SERVICE BULLETIN

Service Bulletin #: SB 01

Title: Compact Flash Removal/Replacement.

This Service Bulletin applies to all Avidyne EX5000C's, with the following software part number:

Figure 1: MFD with Compact Flash Cover Removed

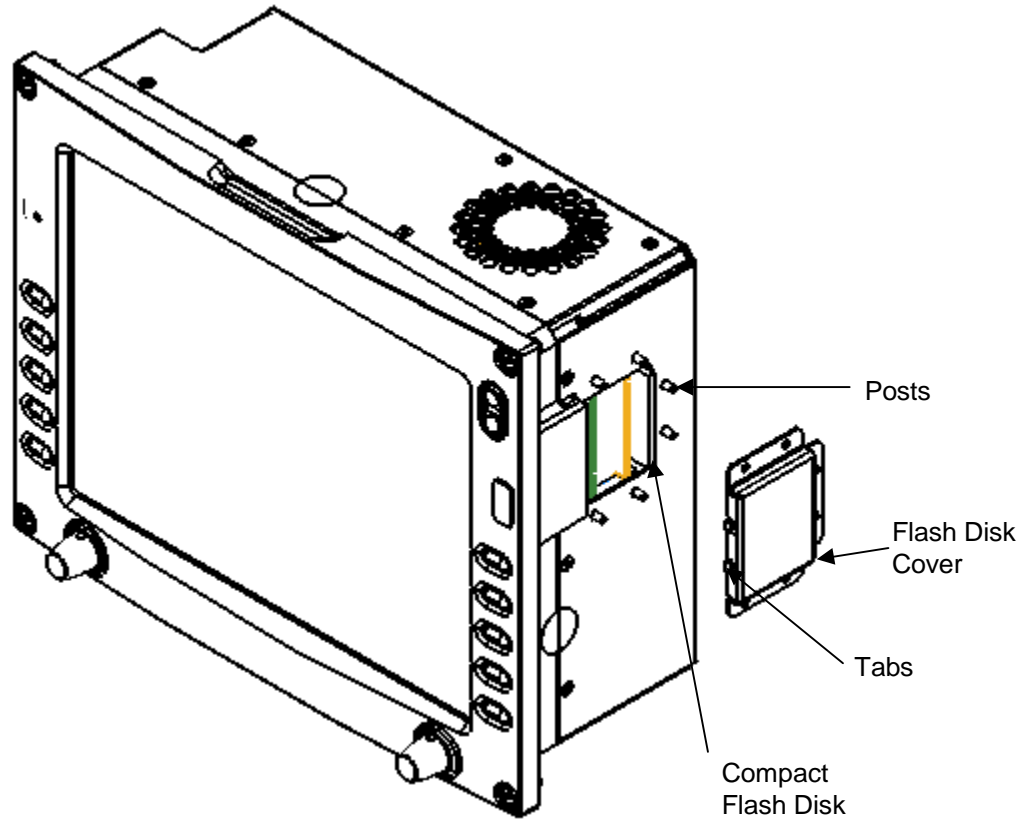
This procedure should be performed on the bench. Ensure NO power is applied to the unit. Refer to Figure 1.

1. Remove the Flash cover by unscrewing the 6 nuts and lifting the cover off the posts.
2. Remove the 530-00112-000 Rev 00 compact flash by pulling it from the connector and sliding it out (as shown in Figure 1).

1. Orient the compact flash by locating the red arrow. This indicates which edge of the device slides in first. The compact flash is keyed, so it will only slide in one way. Look for two small indentations on opposite edges of the device. They should be on the side of the compact flash that faces the front of the unit.
2. Slide the 530-00112-000 Rev 01 compact flash into the slot.
3. Ensure the compact flash is fully seated.
4. Replace the compact flash cover.
5. Secure cover with the nuts.
